Access Compliance Report

Public Rights-of-Way

(Curb Ramps)

Intersection ID: 28215	Main Street: ARDREY_KELL_RD	Cross Street: LANDING_GREEN_DR	Location: W
ADA ID: 68B4DB0B8233	Ramp Type: PerpDiag	Initial Pass/Fail: Pass	Overall Compliance: No
Codes/Mitigation Info/Possible Solution		Field Measurements/Component Compliance	
Severity Score: 5.25

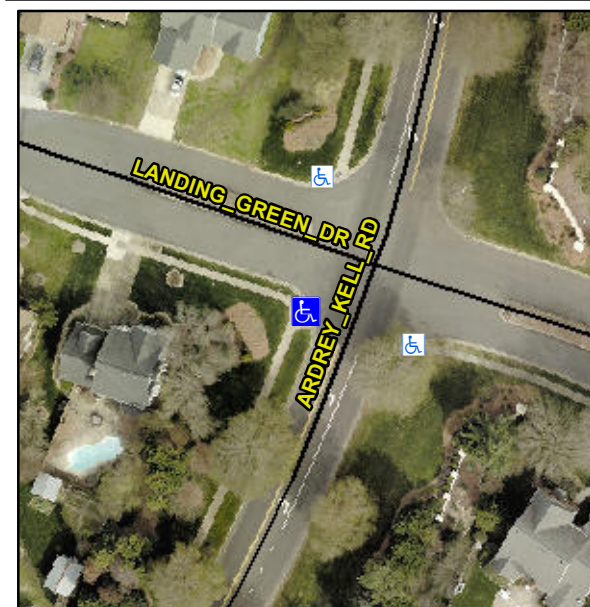
Not Found, R304.5.3, R304.2.2-Perp, R304.3.2-Para, R305.2, R304.5.4

Compliance	Description	Data	Compliance	Description	Data
N/A	Ramp Length (in)	56.0	Yes	Ramp Slope (%)	6.2
Yes	Ramp Width (in)	57.0	No	Ramp XSlope (%)	3.0
N/A	Flare Type LT	Sloped	N/A	Flare Type RT	N/A
N/A	Flare Slope LT (%)	1.5	Yes	Flare Slope RT (%)	7.3
N/A	Flare Traversable LT?	Yes	N/A	Flare Traversable RT?	Yes
Yes	Landing Length (in)	57.0	Yes	DWS Provided?	Yes
Yes	Landing Width (in)	50.5	Yes	DWS Contrast?	Yes
No	Landing Slope (%)	2.7	Yes	DWS Length (in)	24.0
Yes	Landing X Slope (%)	0.9	Yes	DWS Full Width?	Yes
N/A	Landing Curb? (Y/N)	No	No	DWS Offset (in)	3.0
N/A	Shared Landing?	No			
Yes	Gutter Ponding?	No	No	Gutter Slope (%)	6.2
Yes	Gutter Lip Ht (in)	0.0	Yes	Gutter X Slope (%)	1.2
N/A	Painted X Walk1?	No	N/A	Painted X Walk2?	No
	X Walk 1 Direction	To SE		X Walk 2 Direction	To NE
N/A	X Walk 1 Width (in)	N/A	N/A	X Walk 2 Width (in)	N/A
	X Walk 1 Slope (%)	1.2		X Walk 2 Slope (%)	4.8
	X Walk 1 X Slope (%)	2.9		X Walk 2 X Slope (%)	0.9

Remove & Replace Curb Ramp With Two New Directional Ramps or Equivalent. Remove & Replace Gutter.
